7.0 Sixth floor

Revised sixth floor plan with amendments marked in red

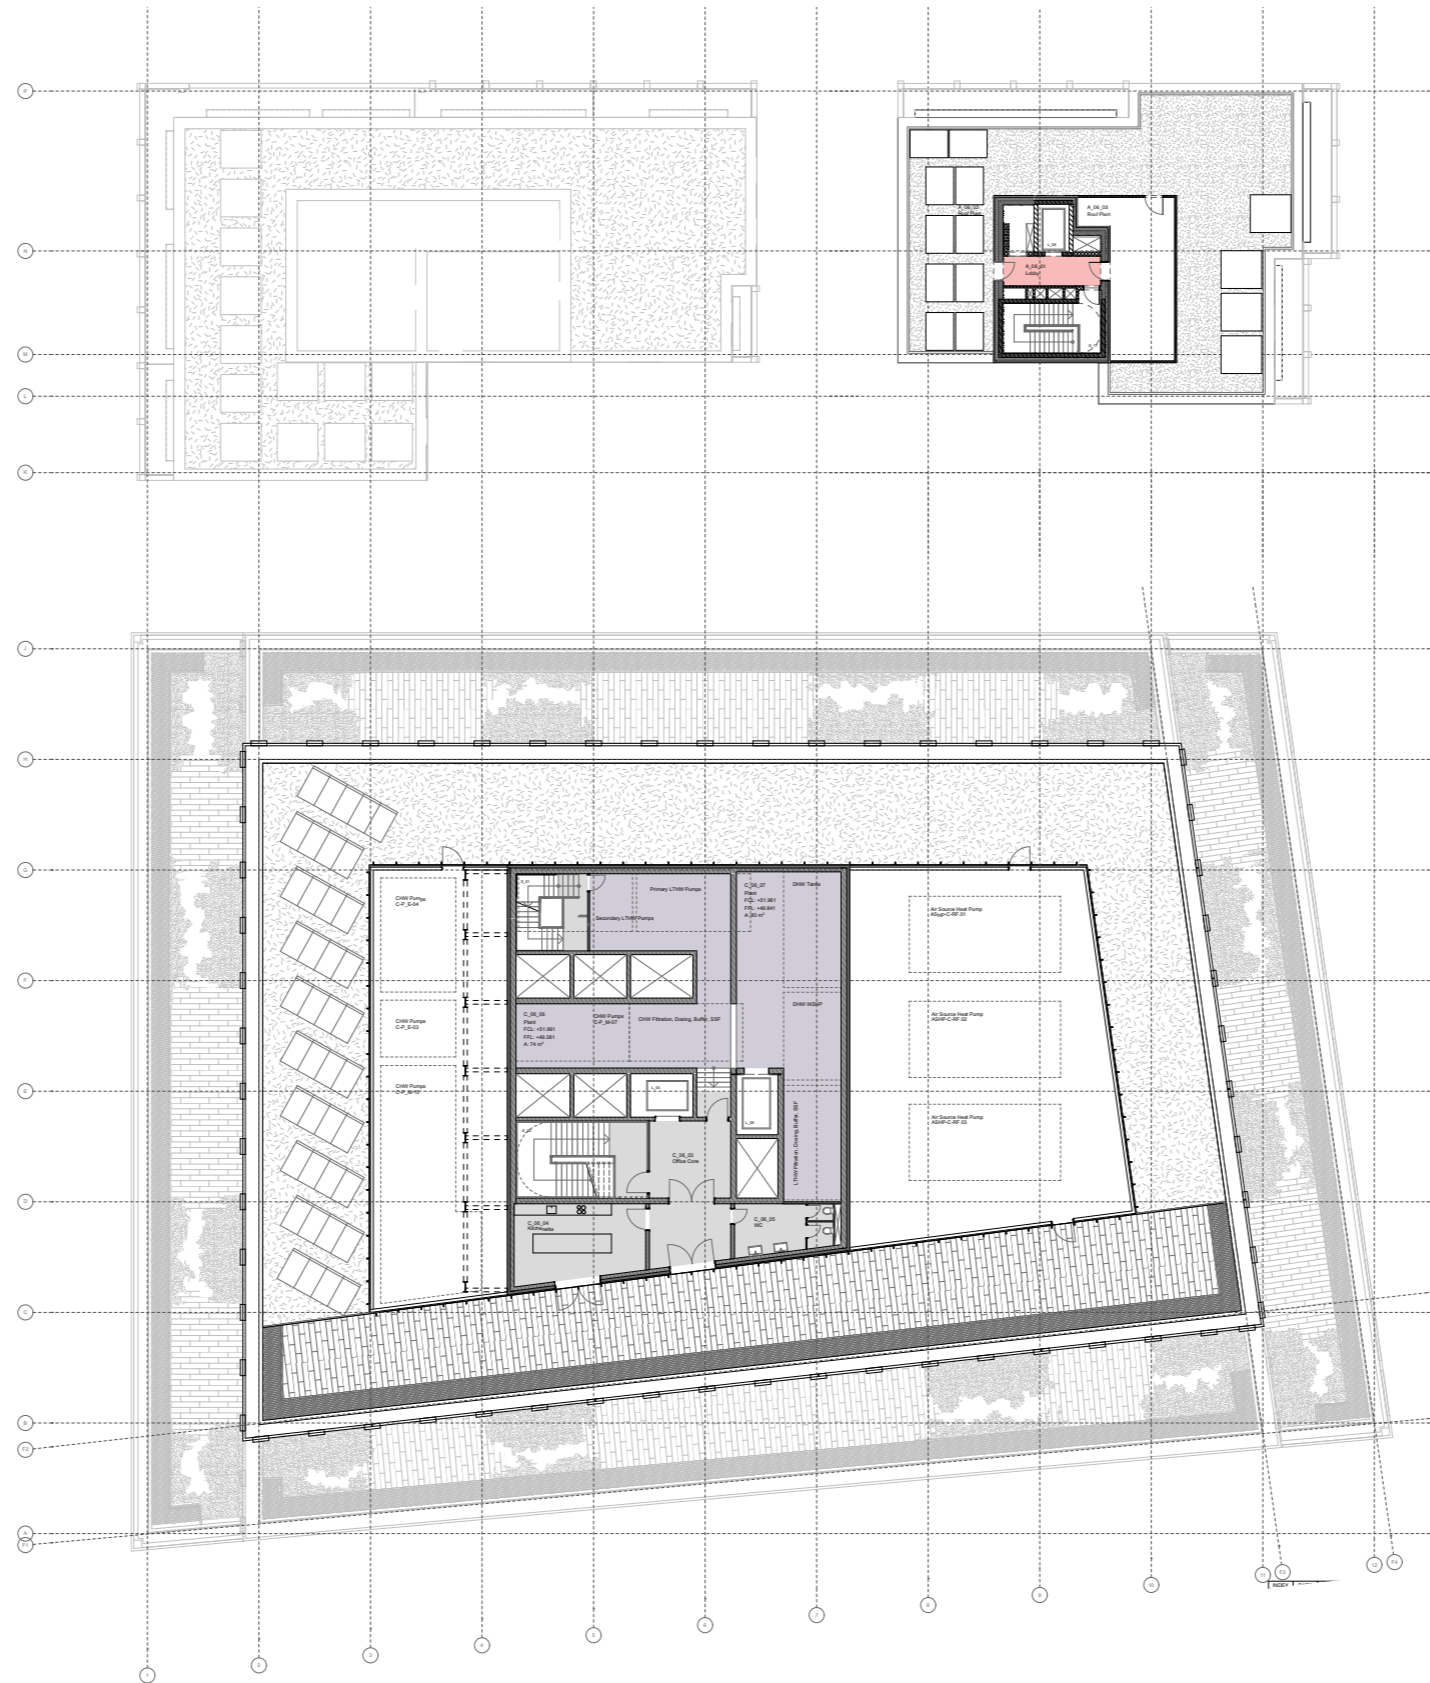
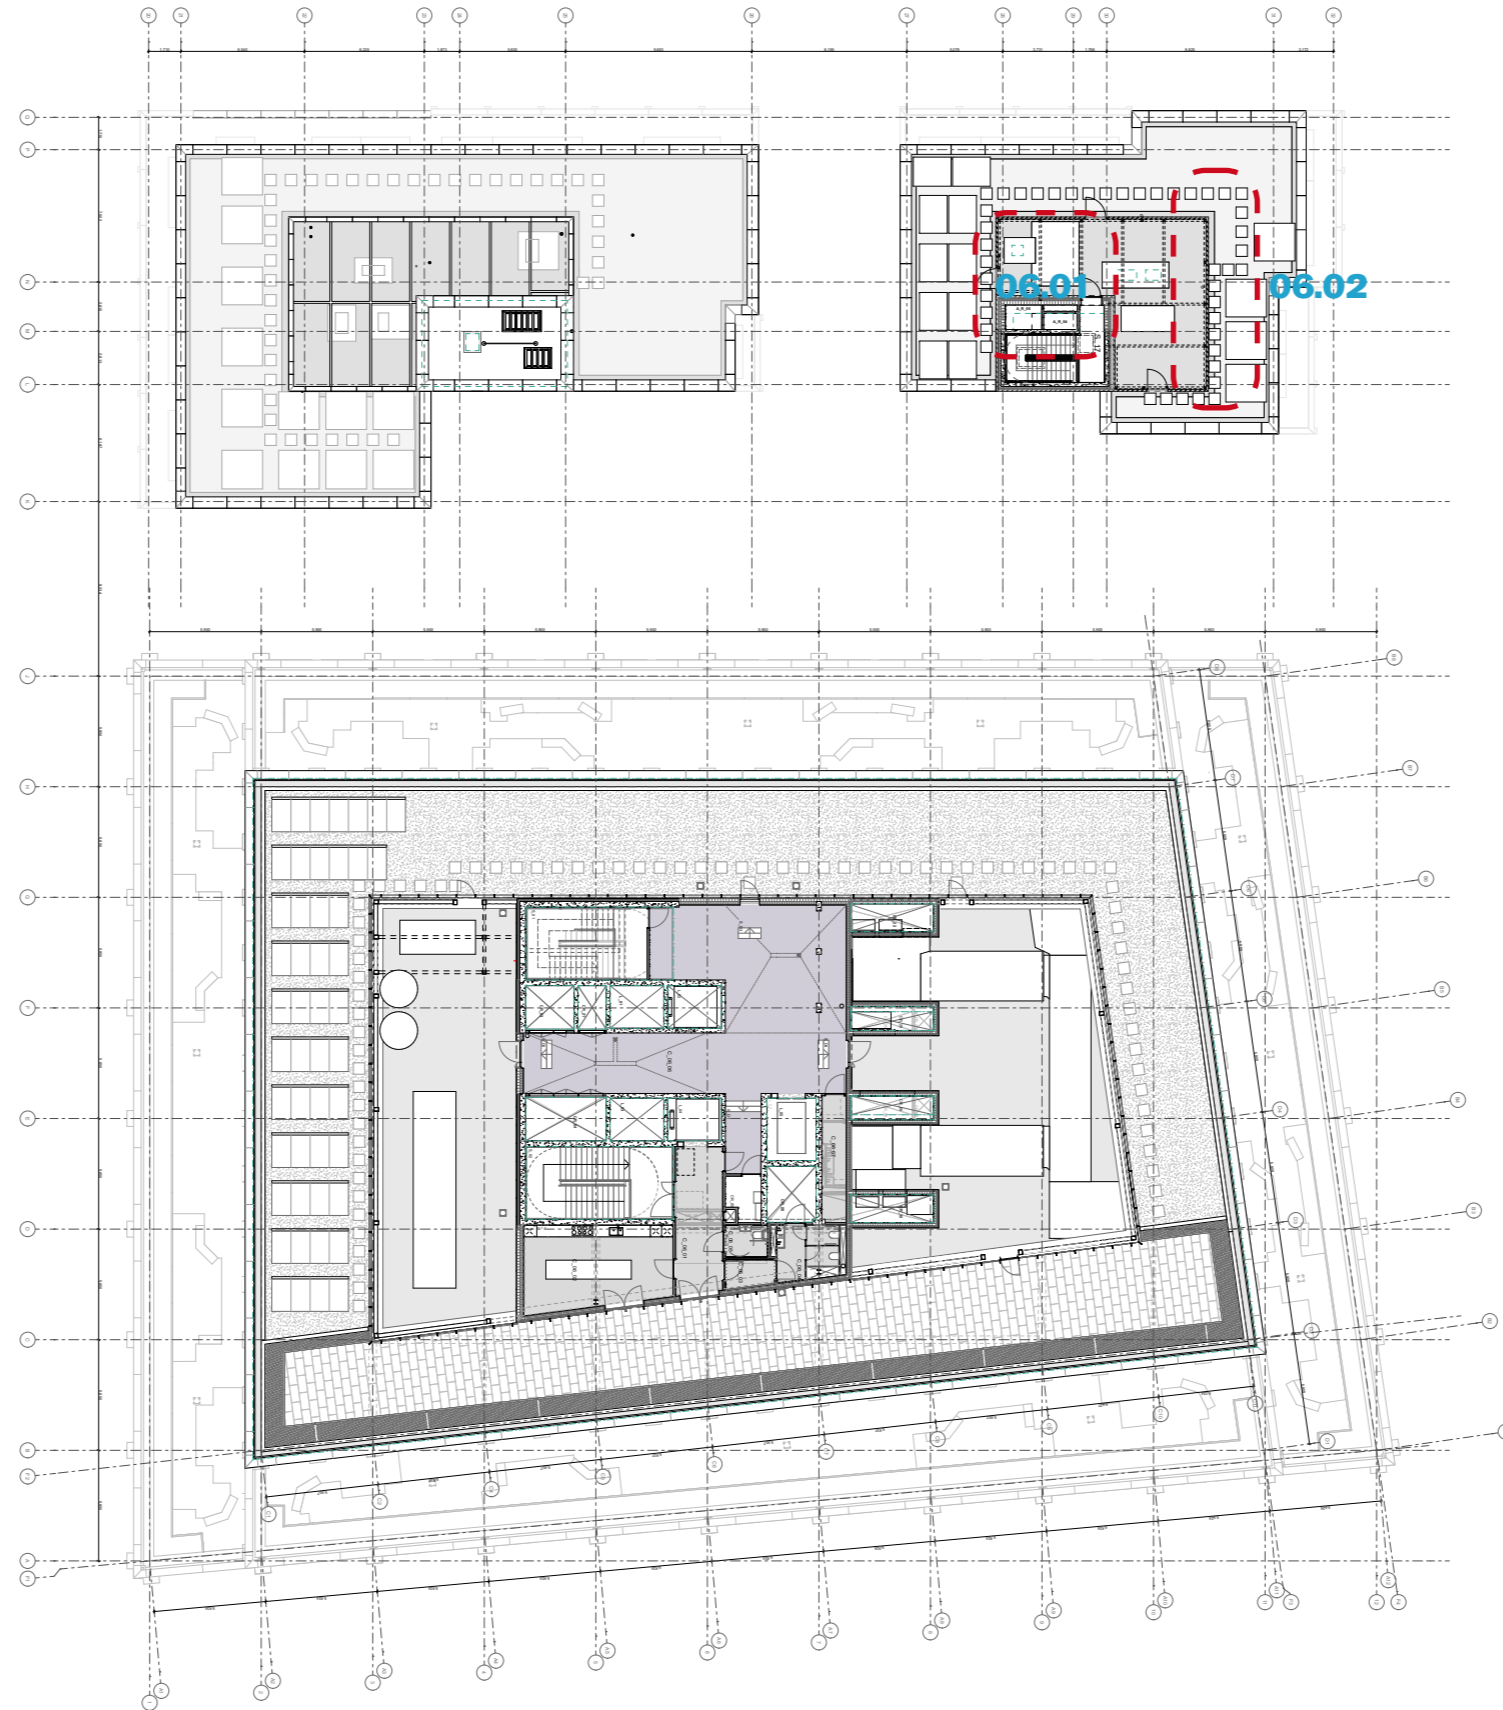
06.01 - Extent of circulation at rooftop level is reduced. See revised area schedule.

06.02 - East wall of plant screen moved 1.5m east to conceal plant equipment.
